UNITED STATES PATENT AND TRADEMARK OFFICE

APPLICATION NO.	FILING DATE	FIRST NAMED INVENTOR	ATTORNEY DOCKET NO.	CONFIRMATION NO.
09/966,163	09/28/2001	Paul E. Burrows	VIT 0012 PA	4083

Office Action Summary

DETAILED ACTION

Harvey, III et al. has an edge-sealed barrier film composite in the embodiment on the next page.

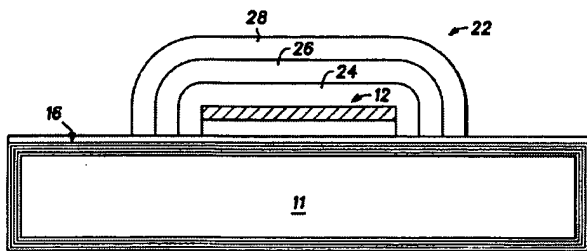
Claims 1-7, 9-10, 12 are met by the recitation of a substrate 11, an environmentally sensitive device (array of pixels of organic light emitting devices susceptible to oxygen and moisture in the surrounding atmosphere) and at least one initial barrier stack 16 adjacent to the substrate comprising at least one decoupling layer 17 and at least one barrier layer 18 (column 4, lines 1-30). Decoupling layer 17 (as defined in the specification, pages 2-3) is formed from organic polymer (column 4, lines 50-70) and barrier layer 18 (as defined in the specification, pages 2-3) is formed from metal (silicon) oxides, metal (silicon) nitrides (column 5, lines 1-10).

If each initial barrier stack is viewed as being composed of one decoupling layer 17 and one barrier layer 18, since the area of the first initial barrier layer 18 closest to the substrate is such that it encapsulates the first initial decoupling layer 17 closest to the substrate, it has an area greater than that of said decoupling layer. The second initial barrier stack then has greater area than the first initial barrier stack, so that the first barrier layer of the first initial barrier stack and the first barrier layer of the second initial barrier stack seal the first decoupling layer of the first initial barrier stack between them since the first decoupling layer of the first initial barrier stack is already sealed by the first barrier layer of the first initial barrier stack in independent claim 1. However, each initial barrier stack may also be viewed as being composed of two alternating decoupling layers and two alternating barrier layers.

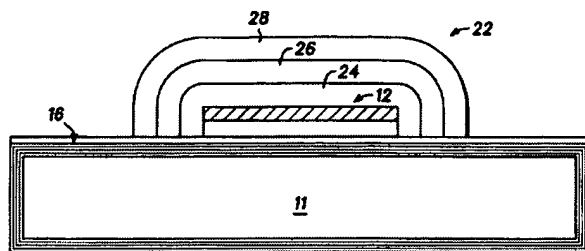
Claim 11 is further met by the recitation of depositing alternating layers of at least one polymer (decoupling layer) and at least one metal (barrier layer) (as defined in the specification, pages 2-3) (column 5, lines 50-70) over the organic device 12 (column 8, lines 15-20) wherein the organic LED array 12 is sealed (with a polymer laminated metal foil) (column 6, lines 55-65). It can be seen in the embodiment below that the environmentally sensitive device 12 is sealed between the at least one initial barrier stack 16 and the at least one additional barrier stack 22.
